PROPOSED REMEDIAL ACTIONS FOR THE
LOCKHEED FACILITIES IN BURBANK

TO: Hank Yacoub
FROM: Al Novak 8/25/87
SUBJECT: Burbank's comments on CALAC interim RAP.

LOCKHEED-CALIFORNIA COMPANY (CALAC) REMEDIAL ACTION PLAN (RAP)

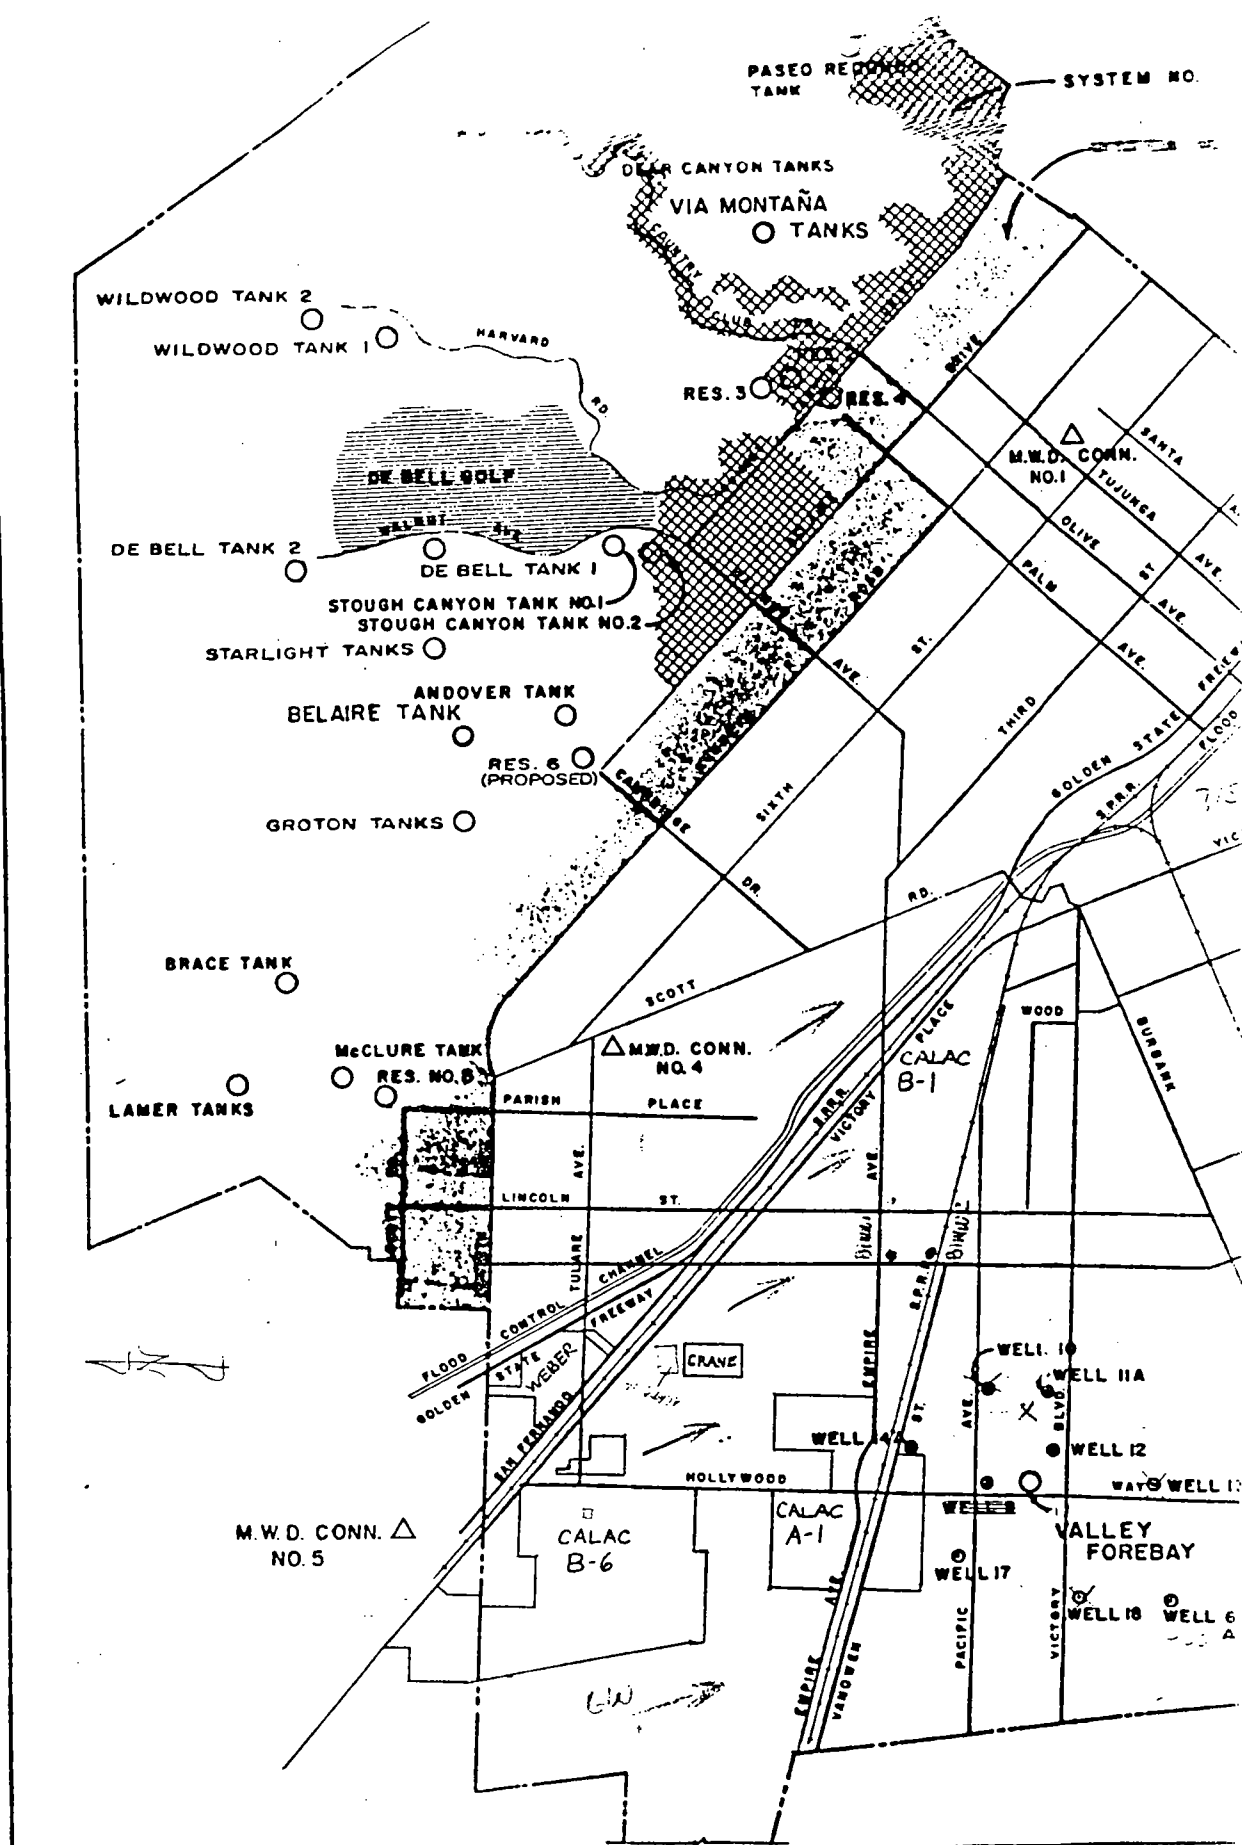
I asked him which wells Burbank felt would be best for intercepting the contaminant plume. He said that he thinks the wells closest to CALAC should be pumped. He thinks that 14A and 10 should be first. Then 11 and 17. Finally 6, 13 and 18 (see attached map).
